Product Change Notice (PCN)

Subject: Change Shipping Media on Select Package

Publication Date: 12/8/2020

Tray Drawing QFN 3mm x 3mm

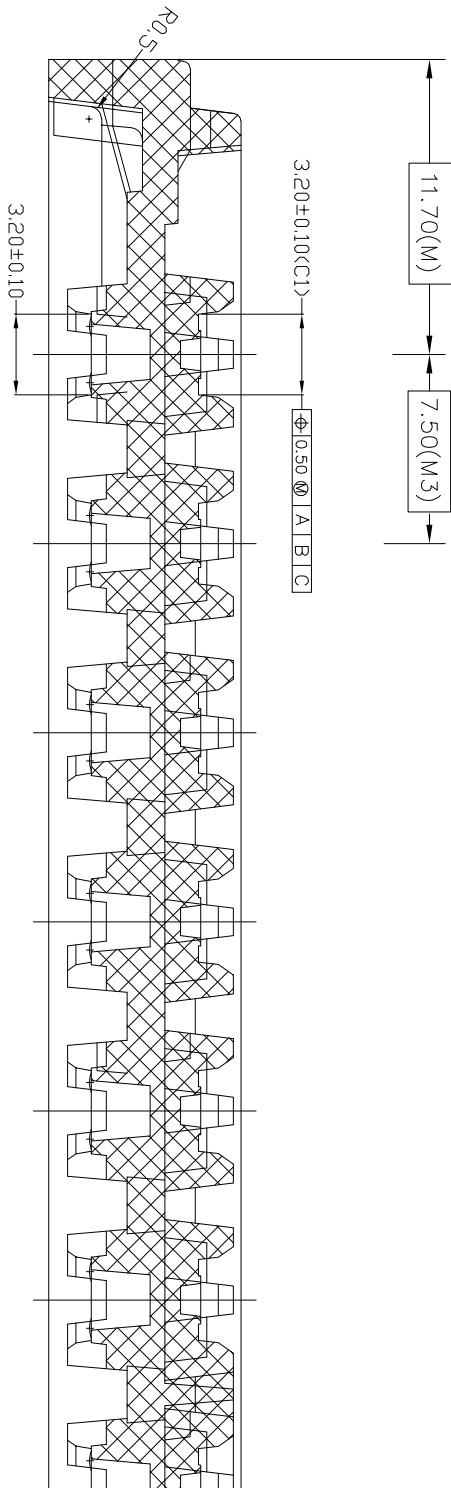
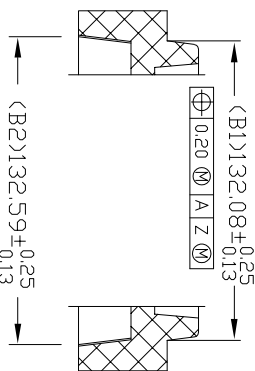
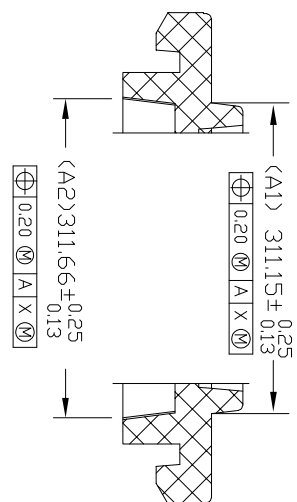
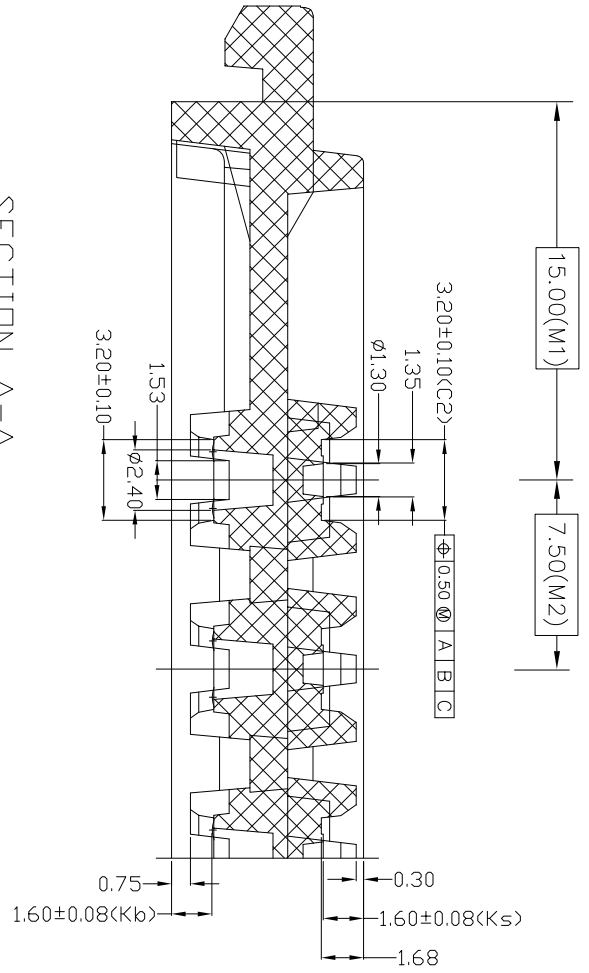
Renesas is converting shipping media from Tube to Tray on package QFN 3mm x 3mm and QFN 4mm x 4mm. The current shipping media in Reel remains unchanged. Industrial standard JEDEC shipping trays will be introduced. Refer Appendix B for tray drawings.
